EXHIBIT 19-A

RE: Recent Seaside Basin Groundwater Model Results

SUBJECT: SEASIDE SUBBASIN GROUNDWATER DIVIDE

Figure 2. Positions of Shallow (orange dashed line) and Deep Aquifer Flow Divide (blue dashed line)

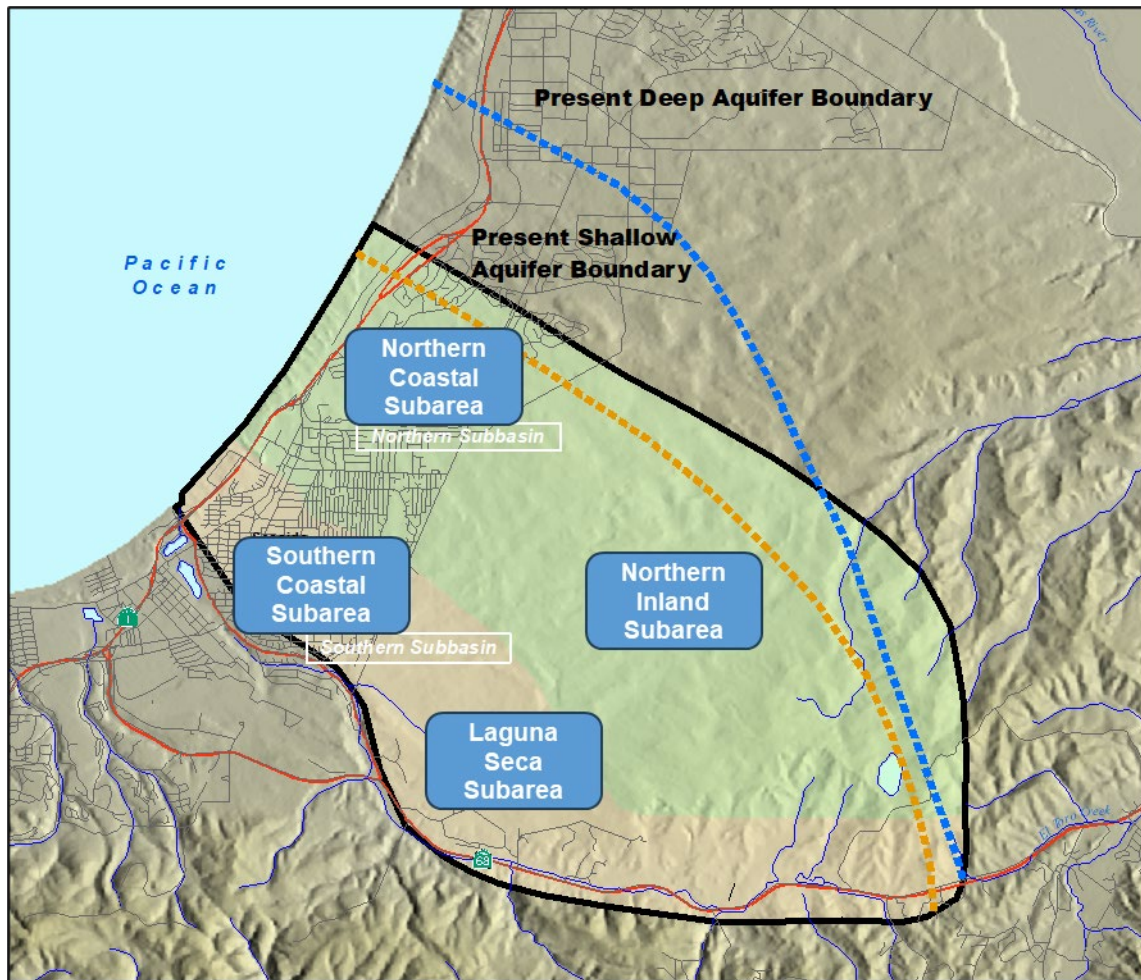
- The positions of the flow divides in the Paso Robles (PR) and Santa Margarita (SM) Aquifers are different (see Figure 2).
- The simulated and mapped position of the flow divides do not align with either the Adjudicated or the DWR Bulletin 118 jurisdictional Basin boundaries (see example on Figure 3).

Figure 3. Plot Showing Simulated Position (yellow area) of Ground Water Divide in the Deep Aquifer

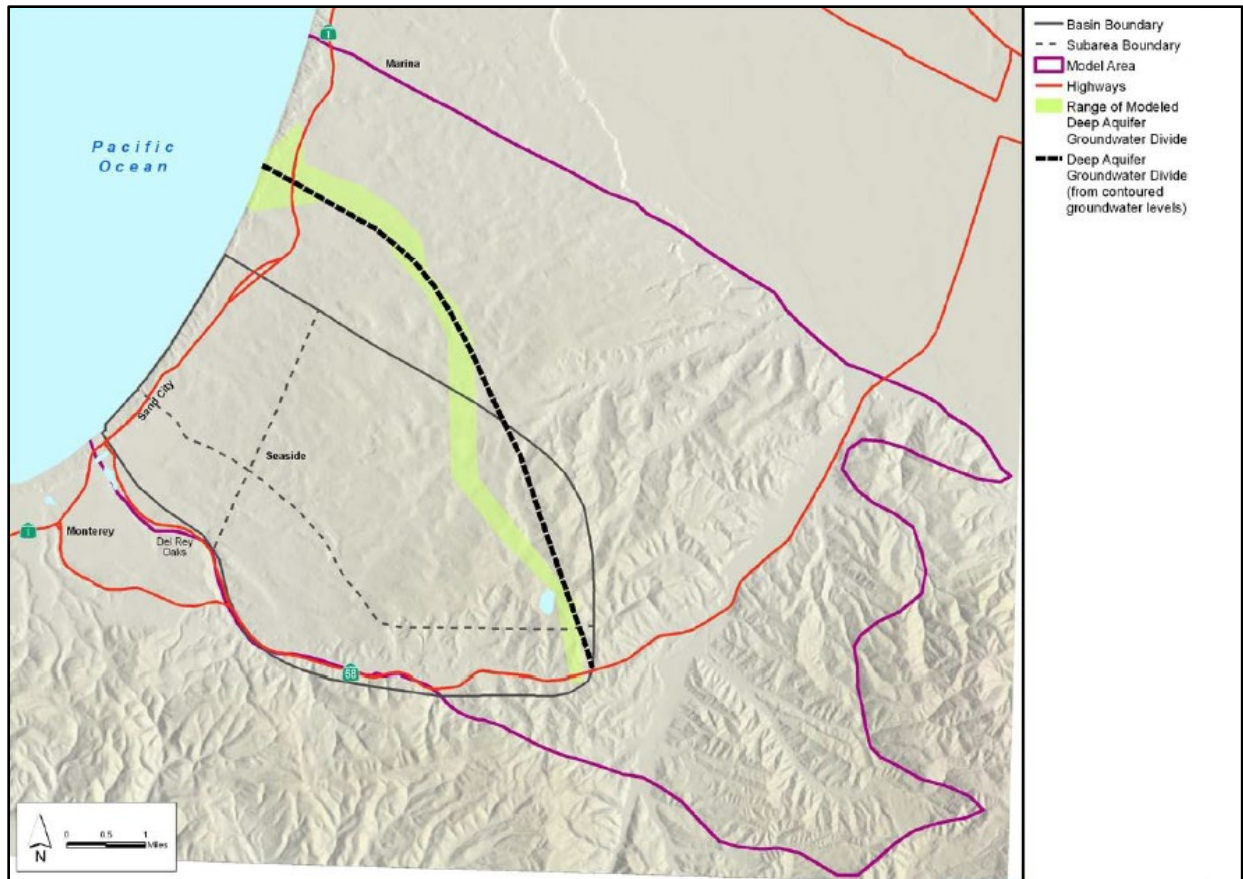
This figure was presented in the 2009 modeling report (HydroMetrics LLC, 2009b). Note that the simulated position of the Deep Aquifer groundwater divide differs significantly from the jurisdictional boundary line (thin black line) and has differences with the Deep Aquifer divide as mapped by Yates *et al.* (2005) from hand contoured 2002 groundwater level data (thick dashed line). The 2009 modeling report did not show or discuss how the simulated Shallow Aquifer groundwater divide compared with the jurisdictional boundary or the Yates *et al.*, Shallow Aquifer boundary, but a brief review of modeling results shows that while similar in a broad sense, they also differ in many places. This suggests that the hand drawn flow divides based on limited water level data sets are simplified representations of more complex and dynamic boundaries.
